Office Action Summary	Application No. 10/054,173	Applicant(s) MALONE ET AL.	
	Examiner Jacob Y. Choi	Art Unit 2875

DETAILED ACTION

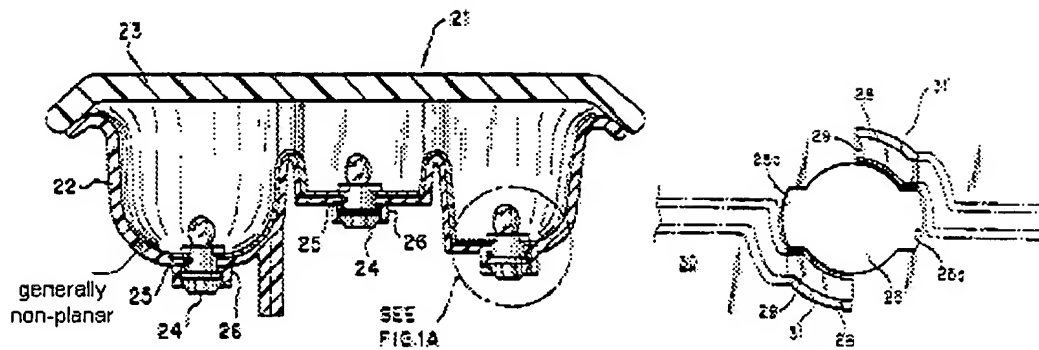
1. Any structural detail that is of sufficient importance to be described should be shown in the drawing (Ex parte Good, 1911 C.D. 43, 164 O.G. 739 (Comm'r Pat. 1911).) See MPEP 608.02. Therefore, applicant needs to show a plurality of compartments, each compartment being generally concave, the conductive material and reflective coating are formed on the substrate within the same vacuum chamber, & the conductive material and reflective coating are formed on the substrate simultaneously in the same vacuum chamber.

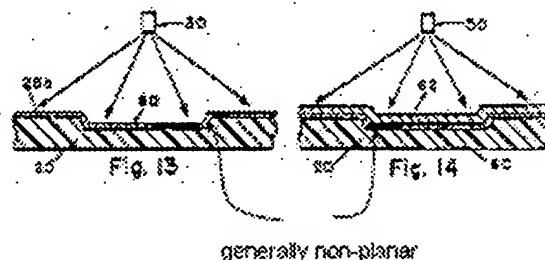
Regarding claims 1, Suzuki et al. discloses the printed circuit board being utilized for a vehicle lamp housing and the conductive material (e.g., 29) is connected to at least one or more light source(s) (e.g., 37) and its power source(s) (e.g., Figures 11-12).

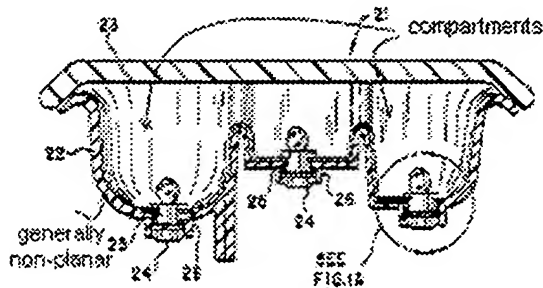
Regarding claim 30, Suzuki et al. in view of Elarde discloses the claimed invention, explained above. In addition, Suzuki et al. disclose the housing comprises one or more smooth corners to facilitate receipt of the conductive layer.

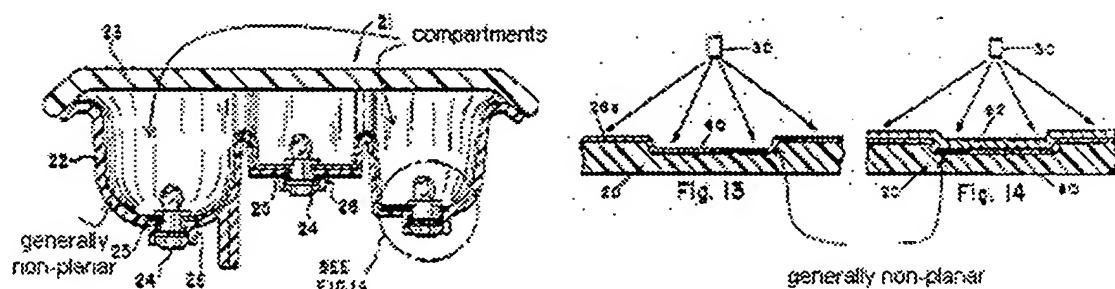
In response to applicant's argument that the references fail to show certain features of applicant's invention, it is noted that the prior art references, Suzuki et al. (USPN 6,290,380) and Elarde (USOPN 4,532,152) clearly shows applying a coating material(s) on a surface that is "generally non-planar" & compartments as indicated below.
